RE: Revised Two Rivers Slope Analysis
Technical Adequacy Review
DRMS Letter Date June 1, 2022

TECHNICAL ADEQUACY REVIEW LETTER

Date: June 1, 2022
To: Rob Zuber
CC: Jason Musick, Michael Cunningham
From: Zach Trujillo
RE: Two Rivers Application, DRMS File No. M-2022-013
Technical Adequacy Review

NON-SEISMIC STABILITY MODEL OUTPUTS

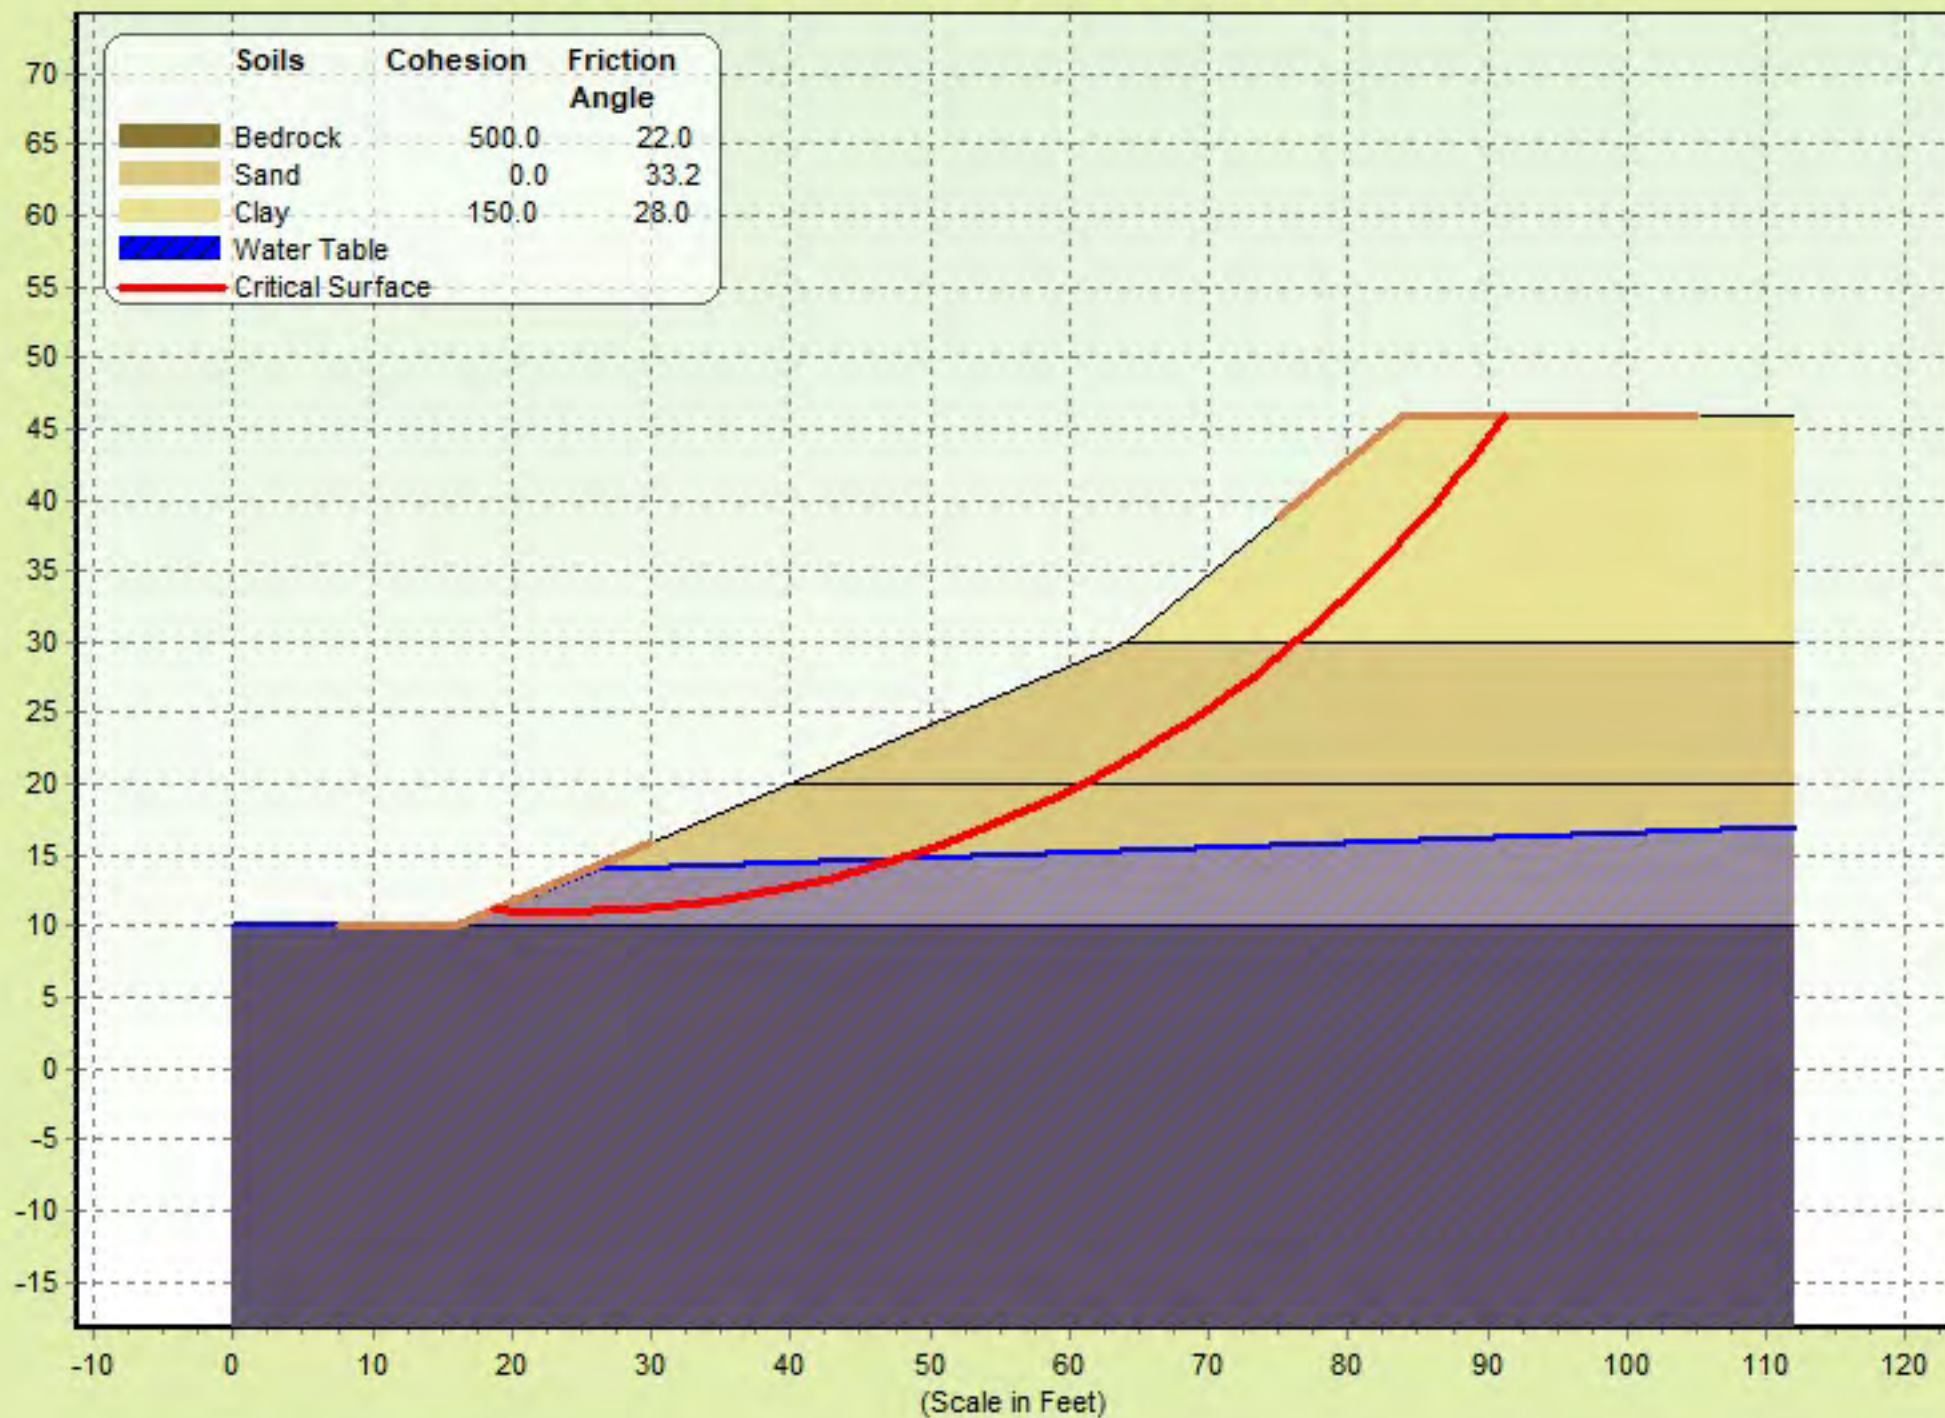
1. **Comment 1 – Please provide an updated slope stability models and associated FoS using the correct friction angle for bedrock.** We reran the four slope configurations with the suggested friction angle of 22 degrees. Predicted factors of safety for the four mine wall scenarios varied between 1.3 and 1.5. Model outputs are presented in Attachment B.

Each resulting FoS from the four analyses indicate slope stability however, there appears to be inconsistencies in the friction angle used for Bedrock as detailed in the cross-sectional slope stability result printouts provided at the end of the Report. Based on Table 1 – Soil Strength Properties, Bedrock has been assigned a friction angle of 22 degrees however of the four analyses, only Plate 4 uses this friction angle. Plate 1, 2 and 3 use a friction angle of 14 degrees. Please see Comments at the end of this memo for requested information.

1. **Please provide updated slope stability models and associated FoS using the correct friction angle for bedrock.**
2. **Please provide additional discussion in regards to conditions or scenarios which determine one of the four proposed highwall slope configuration.**
3. **Please provide slope stability analyses for the four highwall scenarios under seismic conditions including rational for the seismic coefficient used in the analyses.**
